South Coast  
Air Quality Management District

**Review of the Re-Circulated Draft Environmental Impact Report (Draft EIR)  
for the Proposed Mira Loma Commerce Center**

**Figure 1**

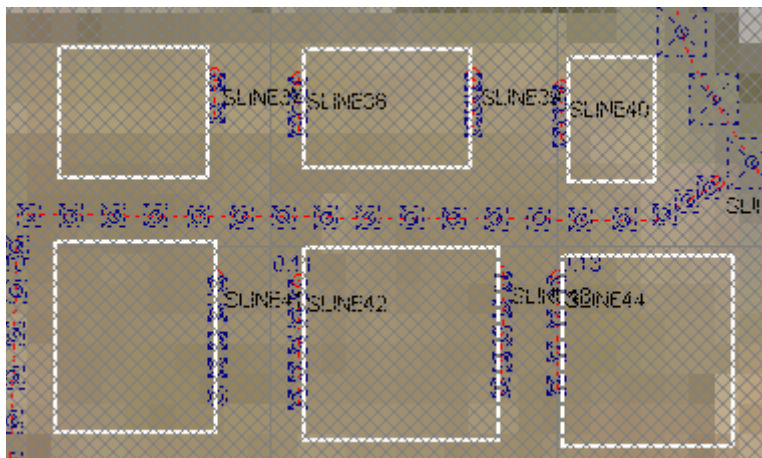
The emissions for each building number were modeled as a series of line sources at each of the physical building structures related to the building number. For example, Building No. 18876 consists of six buildings. Two line sources were assigned to two of the buildings and one line source was assigned to four buildings for a total of eight line sources. The line sources are shown in Figure 1. The smaller line sources labeled SLINE 37 through SLINE 44 represent the idling line sources. Each line source was given the same emissions rate of 6.119E-06, even though the line sources differed in length (and therefore number of volume sources comprising each line source). This approach does not appear to be correct. The correct approach would be to ratio the magnitude of the total emissions from each building number by the length of the line source. So, if the line source used at one physical building is twice as long, the emissions rate from the long line source should be twice the rate as the shorter line source. Care must be taken so that the sum of the emission rates from each of the line sources comprising a building number is the same as the total emission rate estimate in Table 2.

Therefore, the HRA should be redone with the total emission rate from each building number applied to the correct location using line sources with the emissions rates assigned to line sources by length.
